# WARRANTY BULLETIN

CAN-AM® ROADSTER

### SB-10055104-7966

No. **2013-9**

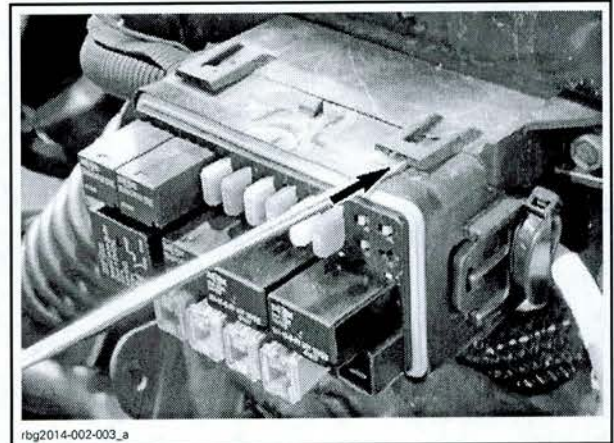
### A - Seal Wire Splices Behind Fuse Box

1. Carefully unclip a fuse box.

TYPICAL LIQUID TAPE APPLICATION

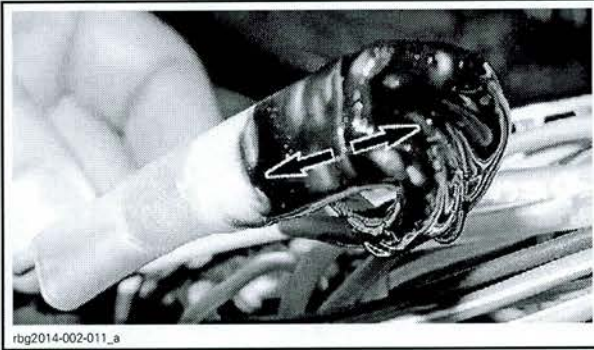
5. Seal both ends of all the wire splices with liquid tape.

**NOTE:** Extend liquid tape onto wires and push the liquid tape into both ends of the splice for a good seal.

TYPICAL LIQUID TAPE APPLICATION

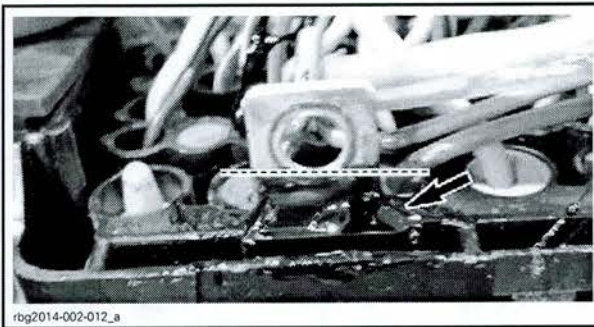
1. Apply liquid tape around the base of the bus-bar. Do not exceed the dotted line area.

TIGHTENING TORQUE	
Power cable to bus-bar nut	5 N•m ± 1 N•m (44 lbf•in ± 9 lbf•in)

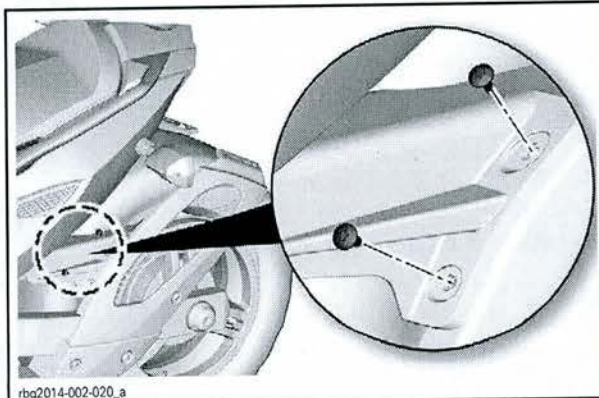
## C - Replace Upper Belt Guard Retaining Screws

Remove and discard screws on vehicle and replace with new screws.

TIGHTENING TORQUE	
Upper belt guard retaining screws	5 N•m ± 7 N•m (44 lbf•in ± 62 lbf•in)
